Product Support Bulletin 2003-014

SUBJECT: Clamp Arm Proximity Switch Interference

MACHINE MODEL(S): Anchor Applicator Model E and F

Figure 1

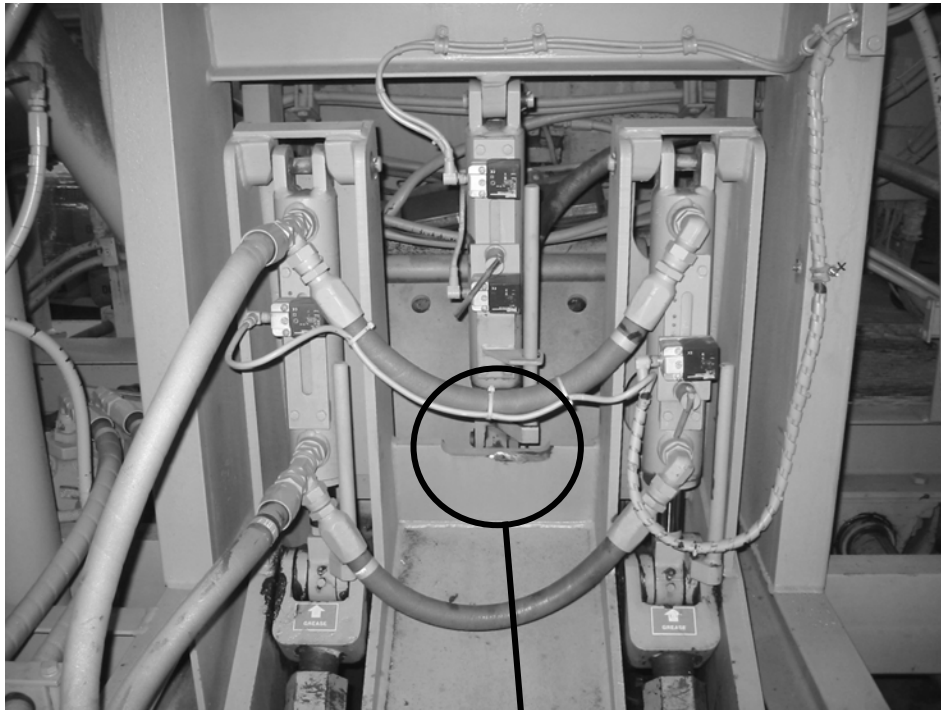
SUMMARY: The Clamp Arm Proximity Switch Actuator can interfere with the Clamp Arm and prevent full extension of the Clamp Arm Cylinder. Only machines with Proximity Switches are affected.

Figure 2

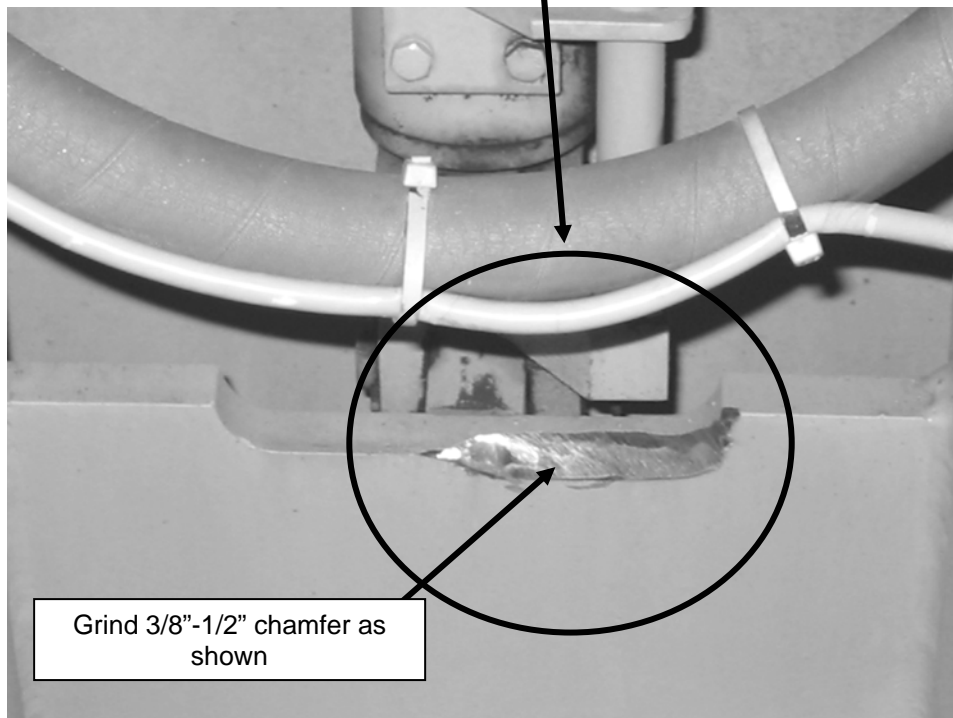
OPERATIONAL IMPACT: The Clamp Arm will not go completely down on 136# and larger rail.

ACTION: A 3/8" – 1/2 " chamfer can be ground in the Clamp Arm can as shown in Figure 2. Alternatively, a redesigned Clamp Arm Cylinder Clevis/Actuator is also available. This clevis will replace the original clevis and is available as p/n 66056860.
